ADDENDUM TO FINAL MITIGATED NEGATIVE DECLARATION FOR THE INTERIM REMOVAL MEASURE (IRM) WORKPLAN PROJECT AT THE ASCON LANDFILL SITE TO ADDRESS THE MODIFIED IRM PROPOSAL PROJECT

JULY 15, 2010

RE: UPDATE TO THE BIOLOGICAL RESOURCES ASSESSMENT FOR THE PROPOSED INTERIM REMOVAL

Existing Southern Tarplant - 2009/2010 Comparison

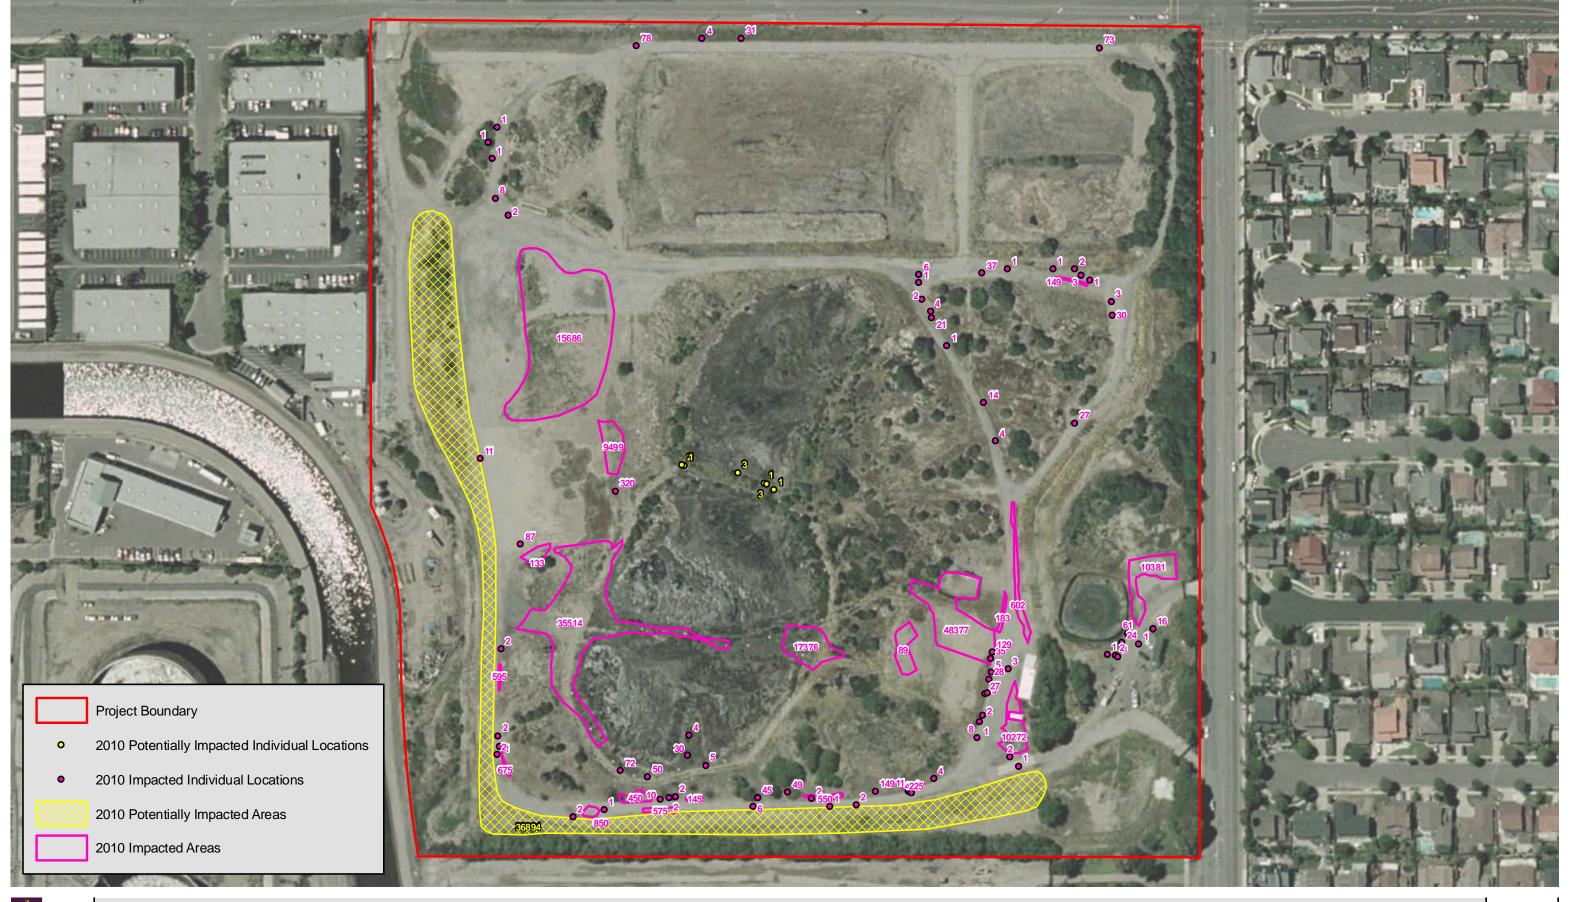
In June 2010, PCR biologists Crysta Dickson and Ezekiel Cooley conducted a Site survey and mapped the existing southern tarplant on the Site. As shown in Figure 3, 2010 Existing Southern Tarplant, attached, approximately 660,476 southern tarplant were mapped throughout a majority of the Site. This represented an increase of 592,618 southern tarplant on the Site as compared to the

approximate 66,858 mapped by PCR in 2009 (Figure 4, Existing Southern Tarplant – 2009/2010 Comparison, attached).
